Agenda Item #5

Certified Record 2026-59-CA

1206 Elmira Street

After-the-fact approval to remove all existing wood windows and replace with vinyl windows; after-the-fact approval to paint brick foundation, knee wall, and column piers.

7. West knee wall of porch painted black

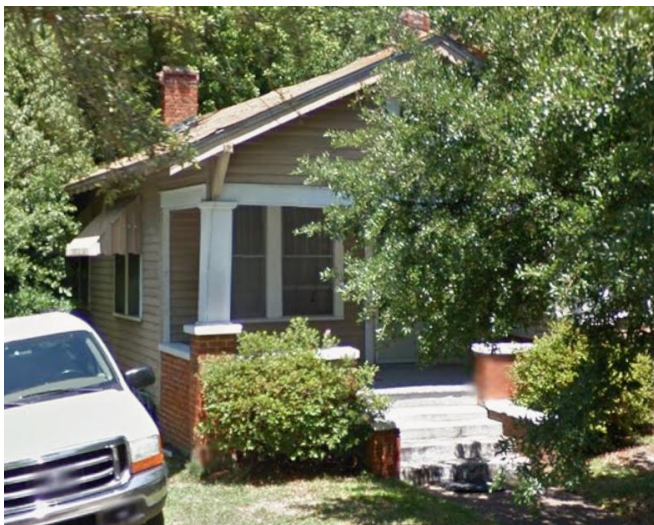
When staff responded to a complaint regarding unpermitted work, the brick foundation and porch were already partially painted. Painting unpainted historic brick is not recommended because it alters the structures original material palette and design intent. Painting can also damage historic masonry if the paint used is not sufficiently vapor permeable. It is not known what type of paint was used in this application. If a masonry-specific paint formula was used, risk to the brick is minor.

The visual impact of the painted brick is far less significant than the inappropriate replacement windows. Painting is limited to the side knee walls of the front porch and the continuous foundation at the south façade. The south walls and steps of the porch remain unpainted. Paint removal is likely to cause damage and is therefore not a realistic mitigation.

10. Original four-over-one windows visible in MHDC survey photo of property (1989)

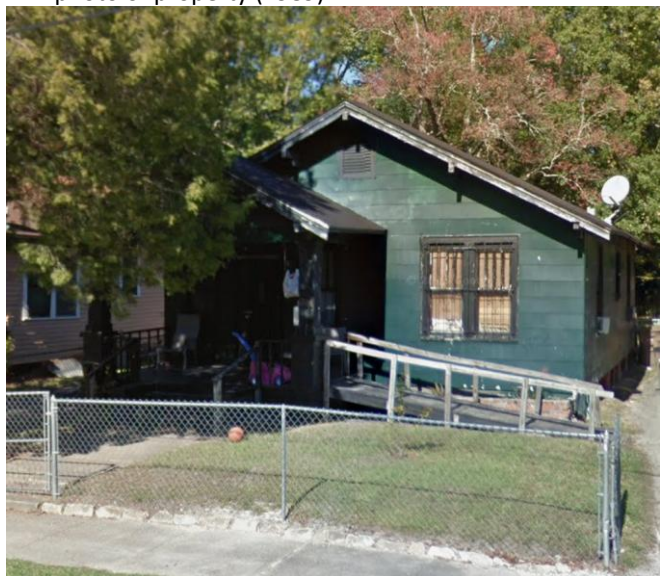
The Design Guidelines explicitly list vinyl as inappropriate for replacement windows in existing structures in the local historic districts. The one-over-one sash configuration does not replicate the original four-over-one double-hung wood windows. However, one-over-one sash windows would have been in common use when the subject property was constructed in 1929. The replacement windows are therefore in keeping with the period of construction even if they do not exactly replicate the original appearance of this specific structure. A one-over-one configuration is also preferable to a four-over-one sash with superficial “stick-on” muntins. The addition of superficial muntins at this point would therefore not be a desirable compromise.
